CITY OF ALBUQUERQUE

RE: 6616 Meadow Lake Place NW
Grading and Drainage Plan
Engineer's Stamp Date: 08/08/21
Engineer's Certification Date: 10/19/21
Hydrology File: E11D026

DRAINAGE AND TRANSPORTATION INFORMATION SHEET (REV 6/2018)

ENGINEER'S SEAL 	LOT 5 BLK 8 UN 7 VC 6616 MEADOW LAKE PL	DRAWN BY DEM
	GRADING AND DRAINAGE PLAN	DATE 3-2-21
 Rio Grande Engineering P.O. BOX 53924 ALBUQUERQUE, NM 87199 (505) 321-9099		LOT 5 BLK 8 UN 7 VC.DWG
		SHEET # C1
DAVID SOULE P.E. #14522		JOB #

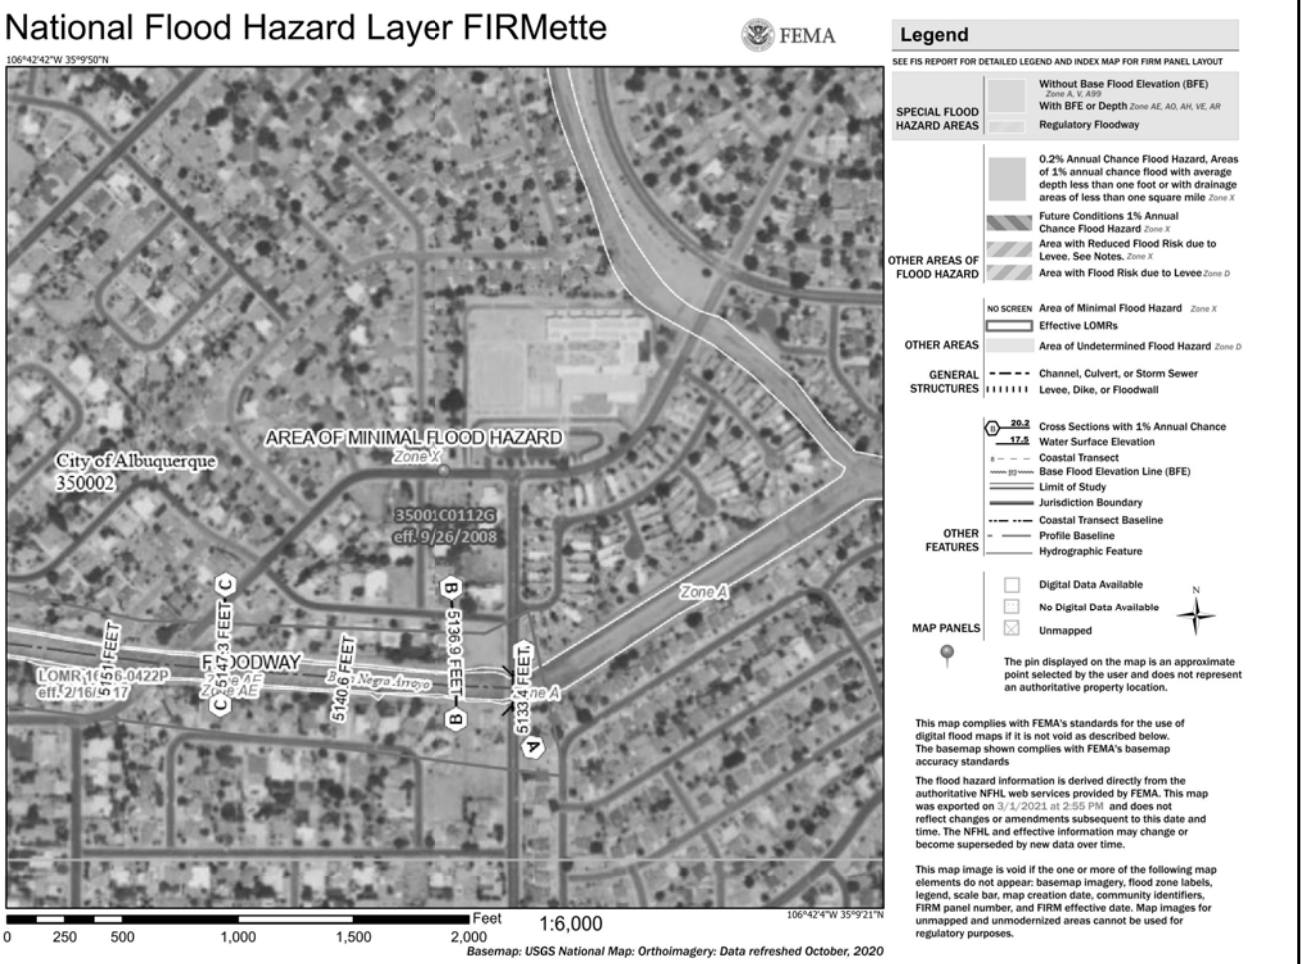
Based upon the information provided in your submittal received 10/19/2021 and site photos sent on 10/27/2021, the Grading and Drainage Plan is approved for Building Permit and Building Pad Certification for 6616 Meadow Lake Place NW. Please attach a copy of this approved plan in the construction sets for Building Permit processing along with a copy of this letter.

Prior to approval in support of Permanent Release of Occupancy by Hydrology, Engineer Certification per the DPM checklist will be required.
